Design Brief

Endeavour Energy Ref: ARP5495
Customer Ref:

ARP5495 – LOT 15, DP 1073816, Asset Relocation Application: 2 A WINDSOR ROAD, MCGRATHS HILL

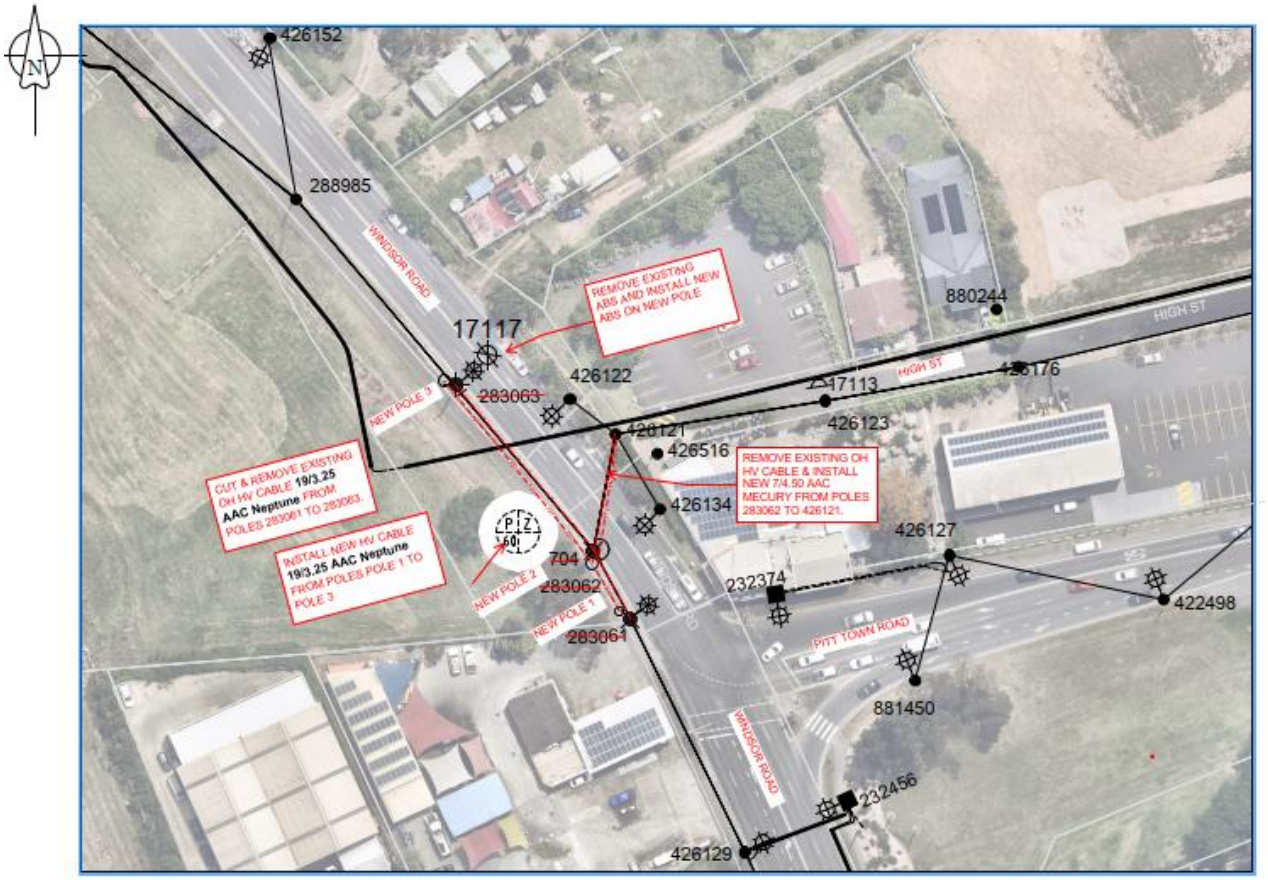
- Relocate existing pole 283061, 283062 & 283063 to the new road alignment as per MDI0031 requirements.
- Remove existing OH HV conductor from poles 283061 to 283063.
- Remove existing OH HV conductor from pole 283062 to pole 426121.
- Install **new ABS** on new pole 3. New Air break switch earthing as per EDI0006 & drawing B348252
- Install new OH HV conductor **19/3.25 AAC Neptune** from new poles 1 to 3.
- Install new OH HV conductor 7/4.50 AAC from new pole 2 to pole 426121.
- All OH line design as per MDI0031 & MCI0005.

- Relocate existing pole 283061, 283062 & 283063 to the new road alignment as per MDI0031 requirements.
- Redirect the existing LV OH conductor to new poles 1 & 2. If the existing LV conductor length is insufficient, terminate existing LV conductor 7/4.50AAV on new pole 1 & install new span of LV bare 7/4.50AAC from new poles 1 to 2.
- Remove existing OH LV conductor from pole 283062 to pole 426121.
- Install new OH LV conductor 7/4.50AAC from new pole 2 to pole 426121.
- All OH line design as per MDI0031 & MCI0005.

- Relocate existing pole 283061, 283062 & 283063 to the new road alignment as per MDI0031 requirements.
- Remove existing OH SL conductor from pole 283062 to pole 426121 and from pole 283062 to

pole 283063.

- Remove existing SLCP 704 on pole 283062.
- Existing OH SL conductor to be redirected from pole 426129 to new pole 1 & pole 2.
- Install new SL conductor 25mm^2 2C from new pole 2 to pole 426121 and from new pole 2 to pole 3.
- Remove all existing street lighting on poles 283061 & 283063.
- Install new streetlighting on new poles 1 & 3 as per LDI0001 requirements.
- Install new additional luminaires and light pole as per the lighting assessment.
- All OH line design as per MDI0031 & MCI0005.
